WATERBURY FILING NO. 1 EL PASO COUNTY, CO CONSTRUCTION SET FEBRUARY 2023

EPC STORMWATER REVIEW COMMENTS IN ORANGE BOXES WITH BLACK TEXT

**OUTLET STRUCTURE MODIFIED TYPE 1 MH**  
 SCALE: 1"=2'

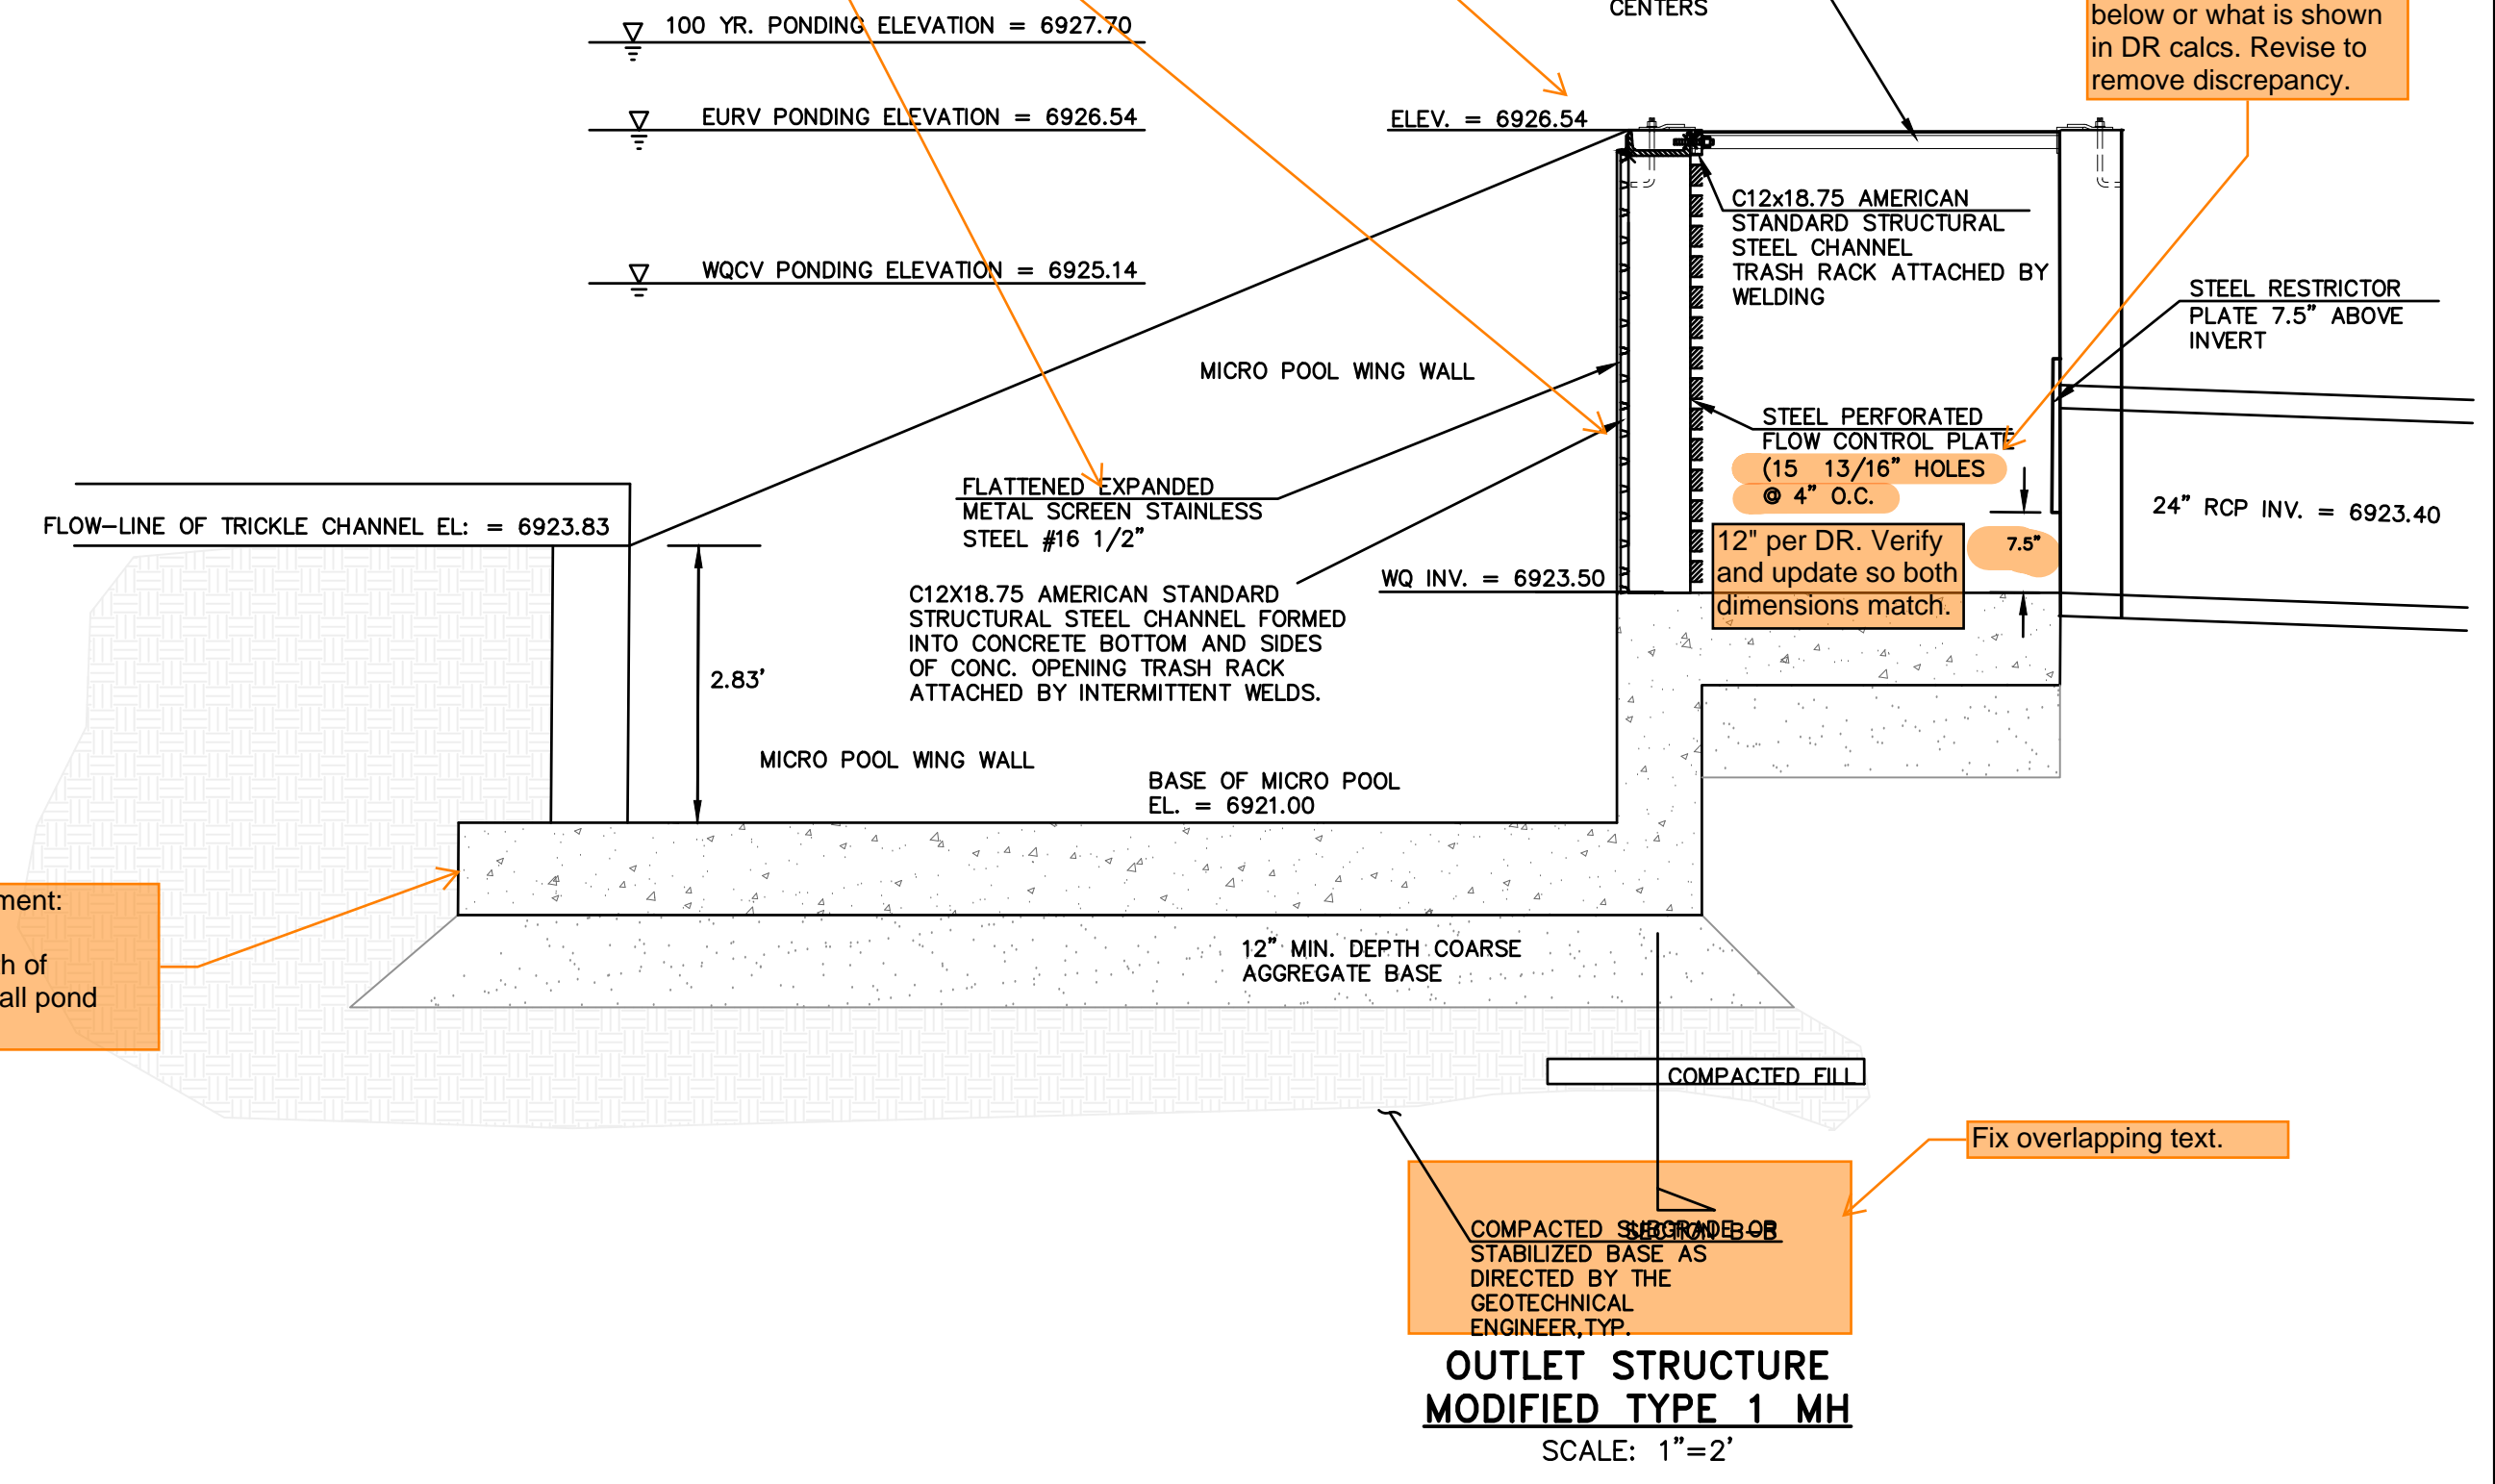
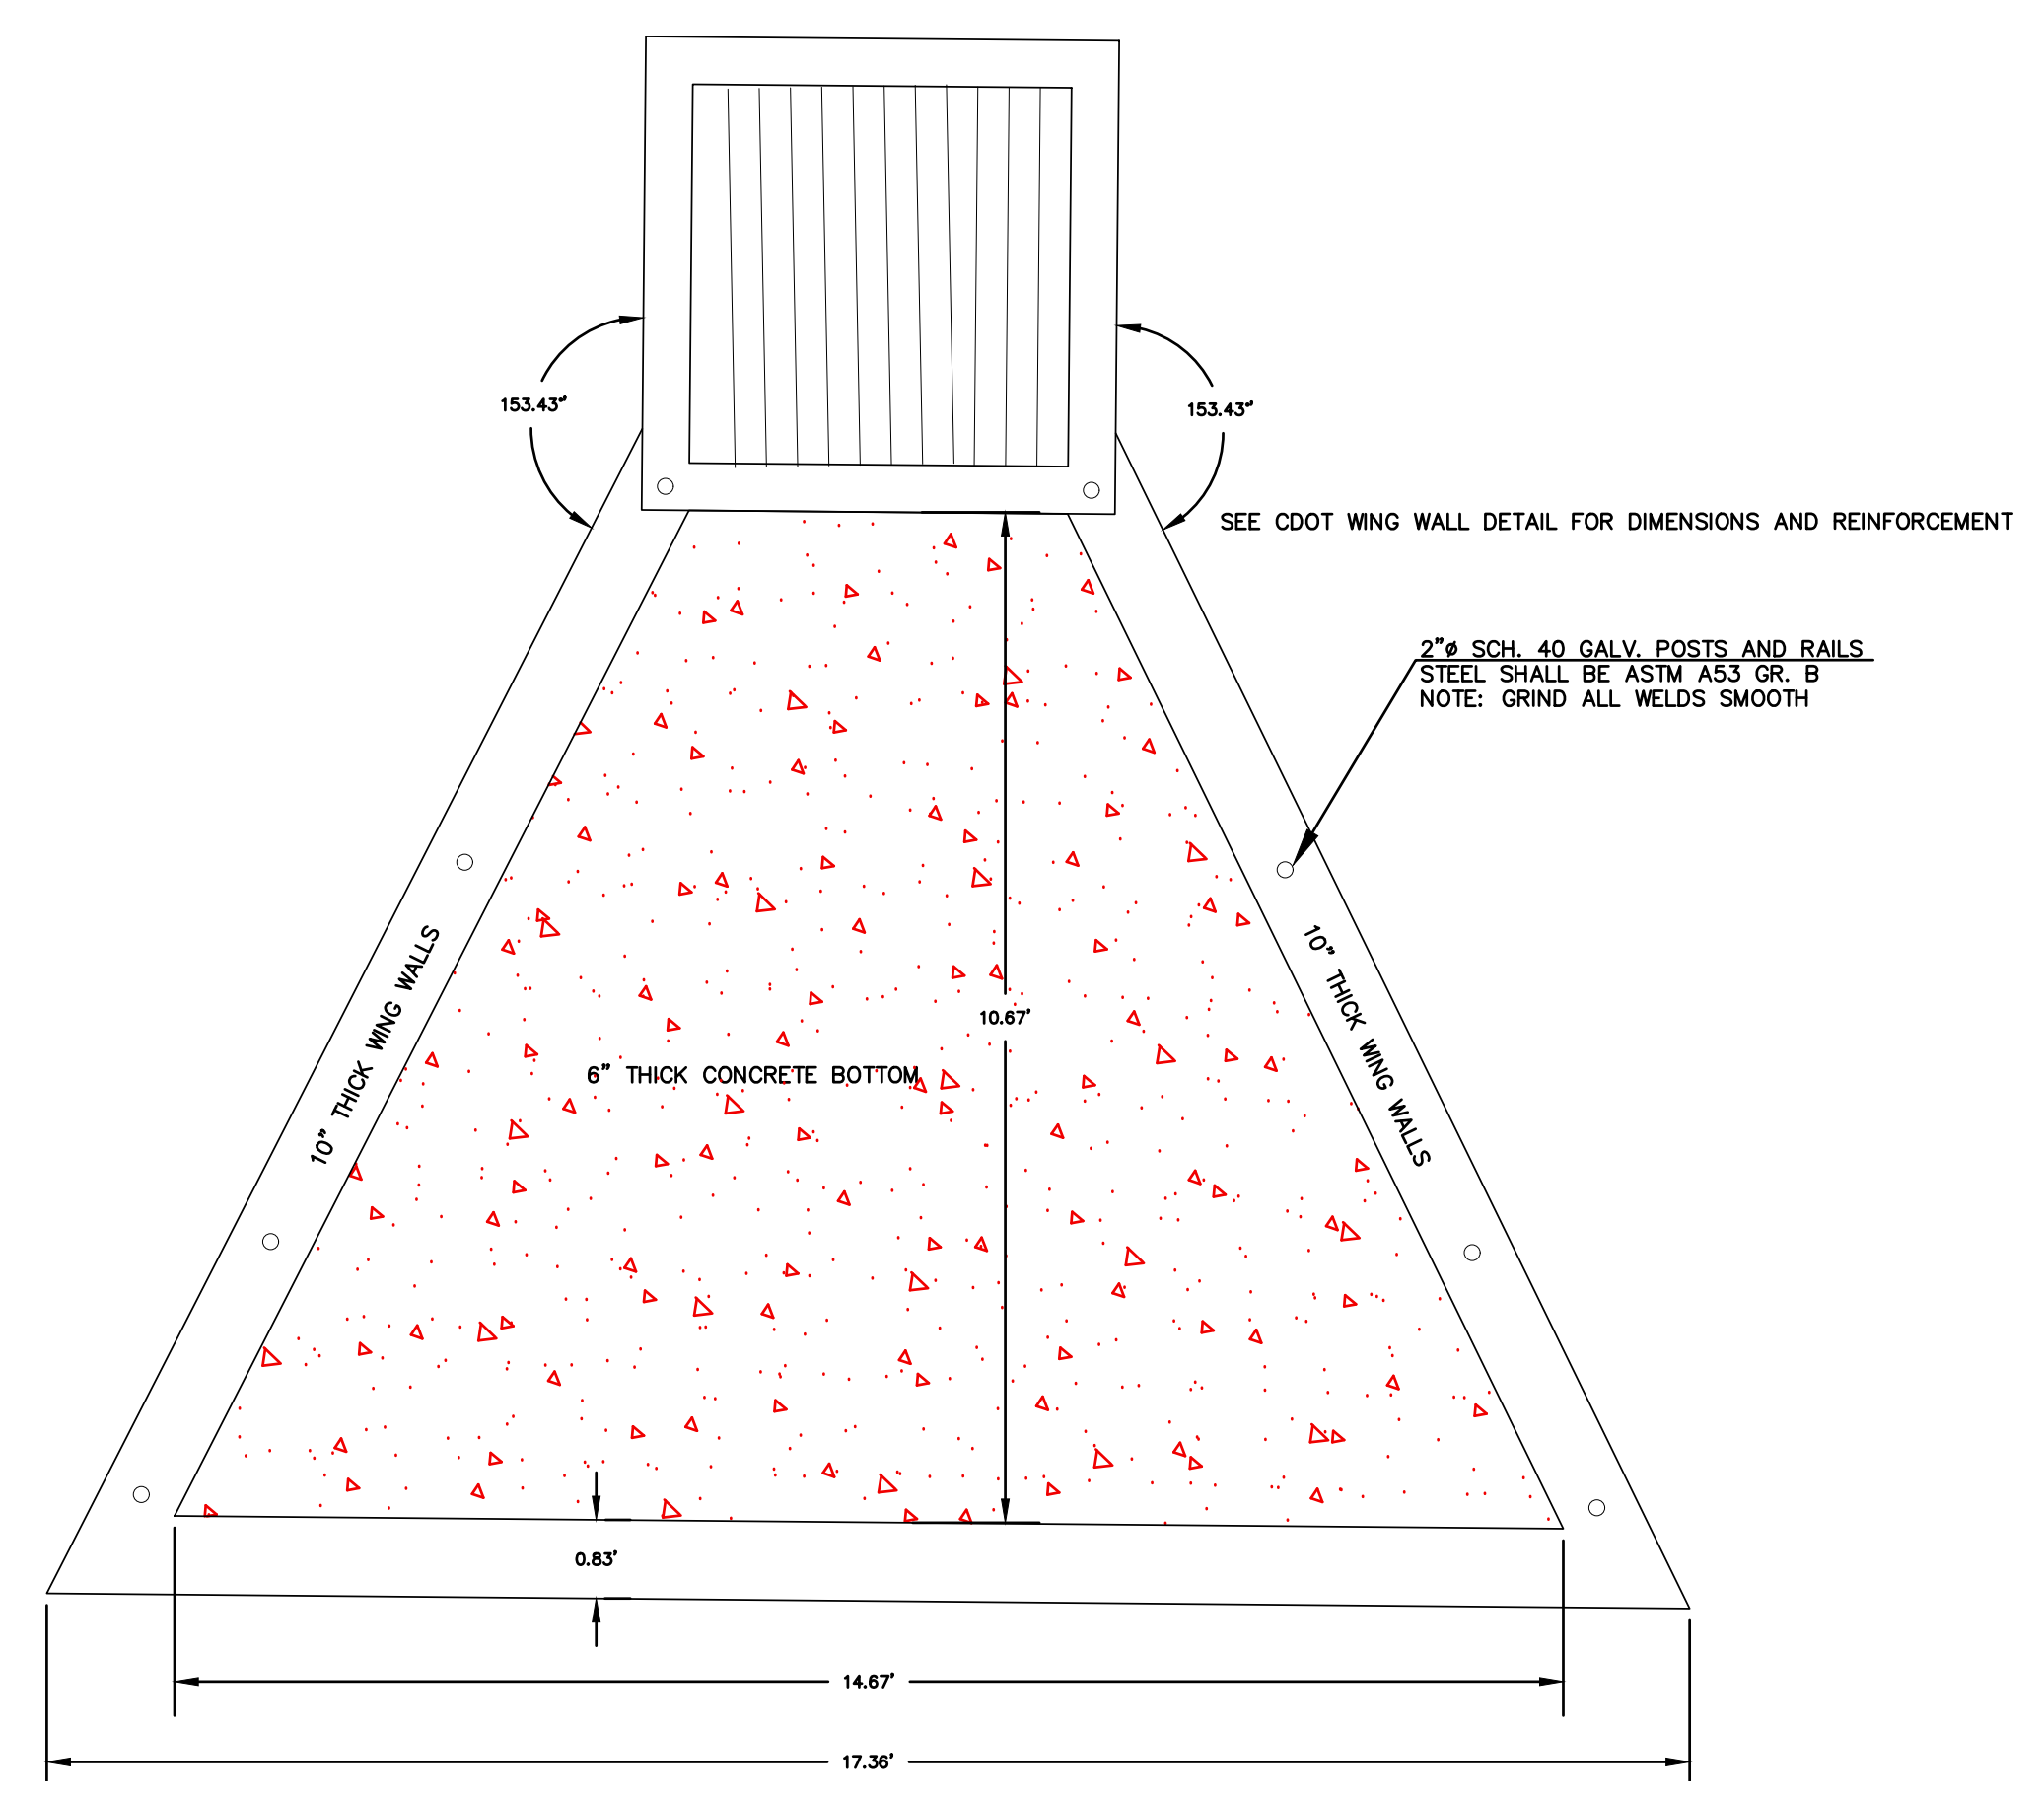
4ft per calcs in DR. Revise to remove discrepancy.

Trash rack to be Amico Klemp KRP Series aluminum bar grate (Figure 6-b), US Filter or Johnson stainless steel well screen with #93 VEE wire (Figure 6-a), or equivalent (per EPC DCMV2, Chap 4.3 and MHFD Detail T-12).  
 Diamond plate trash racks are not an equivalent replacement to those in our criteria. We have concerns that the diamond plate is going to be a constant maintenance issue with clogging. Diamond plates may have the same percent open area as those shown in our criteria but this isn't the only criteria that decides equivalency with the ones specified in our criteria. The well screen and bar grates in our criteria are designed to be maintenance friendly whereas the diamond plate will clog more often.

Typical comment for all 3 ponds:  
 Wellscreen and concrete channel between wellscreens and orifice plate should extend down to the bottom of the micropool per MHFD Detail T-5, page EDB-5.

Does not match detail below or what is shown in DR calcs. Revise to remove discrepancy.

Typical comment:  
 Provide depth of concrete for all pond structures.

**EMERGENCY SPILLWAY CROSS SECTION**  
 SCALE: N.T.S.

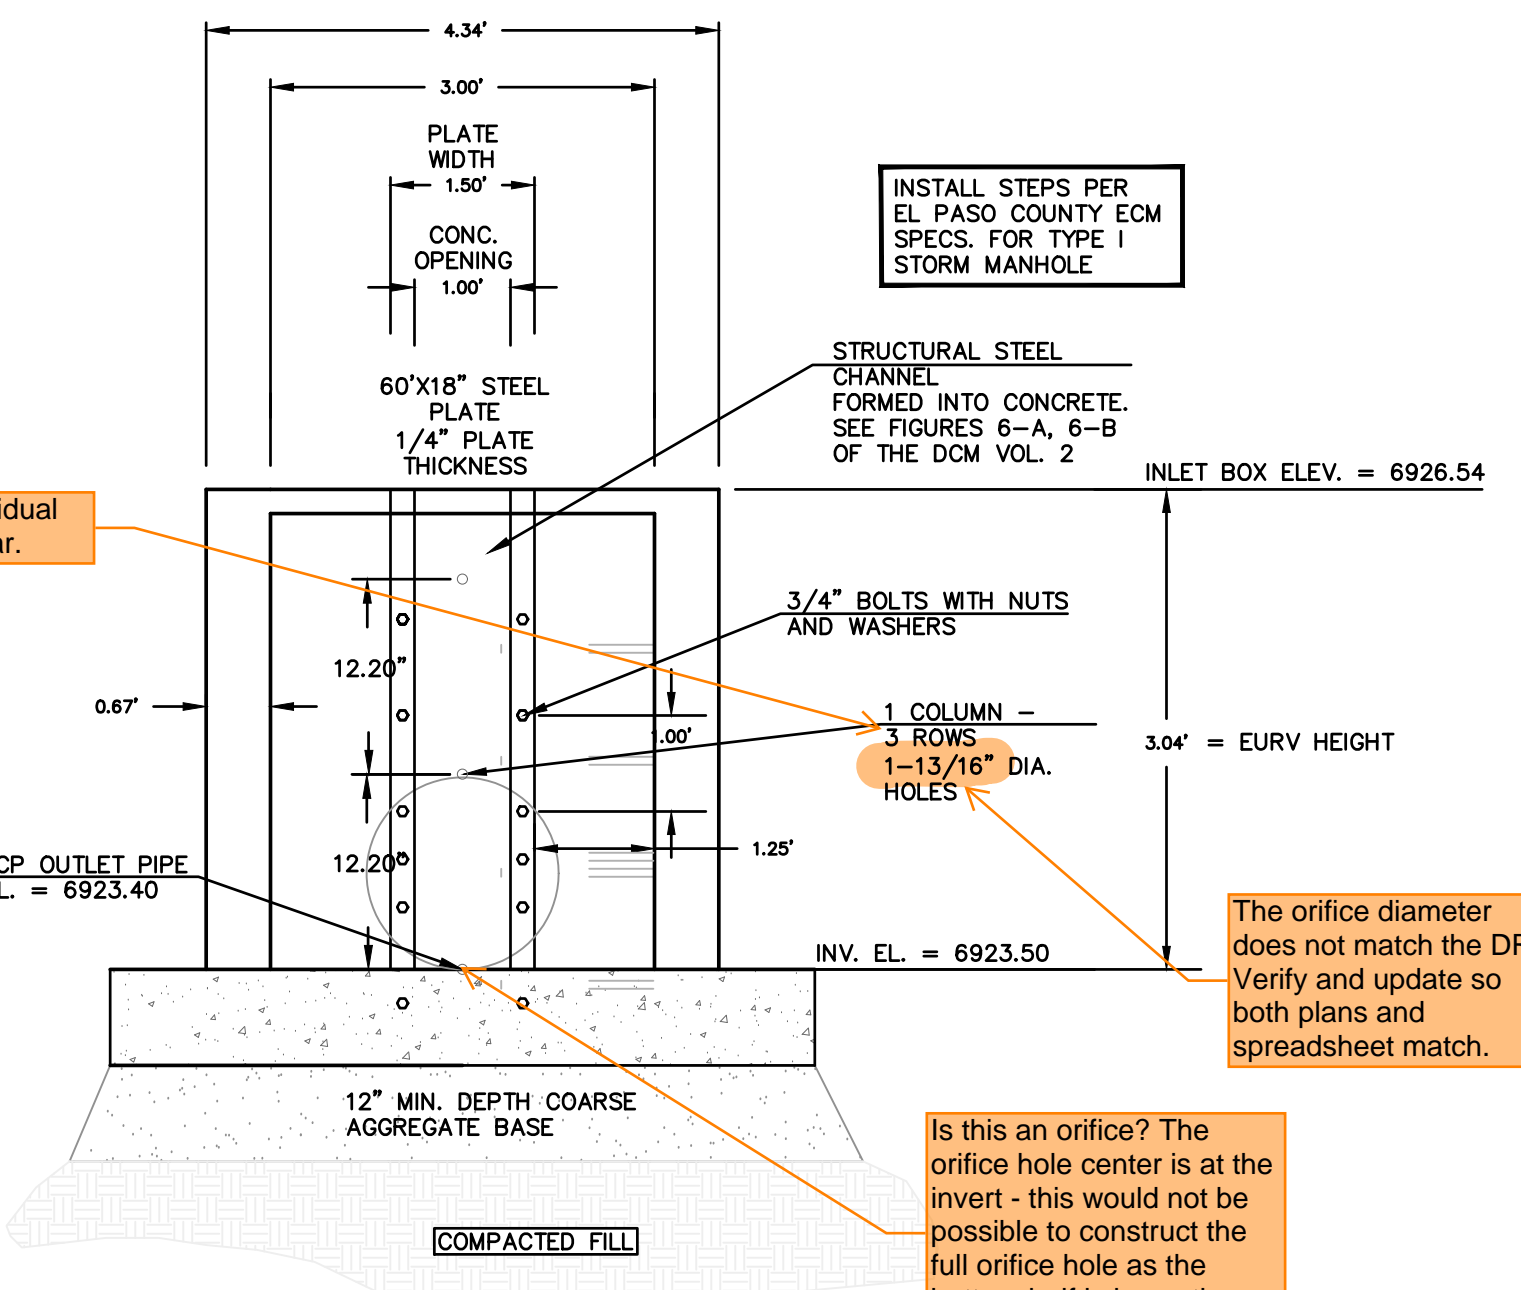
Typical comment for all 3 ponds:  
 Provide maintenance access road detail/cross section, including stone sizing and gradation. Show cross slope at 2%.  
 Stabilized access ramp shall be a minimum of 15ft wide and no greater than 12% slope, in accordance with DCMV1, Chap 11.2.2.  
 Consider using a base course that will minimize migration of fines when the pond is detaining water.

The orifice diameter does not match the DR. Verify and update so both plans and spreadsheet match.

Typical comment for similar details on all 3 ponds:  
 Pond bottom should have a minimum slope of 3% to the trickle channel and micropool (USDCM Vol 3, detail T-5). Please adjust to minimize future maintenance needs.

Typical comment for similar details on all 3 ponds:  
 Consider having control joints every ~10ft.  
 Per MHFD Detail T-5, a longitudinal slope between 0.4-1% is recommended to encourage settling while reducing the potential for low points.
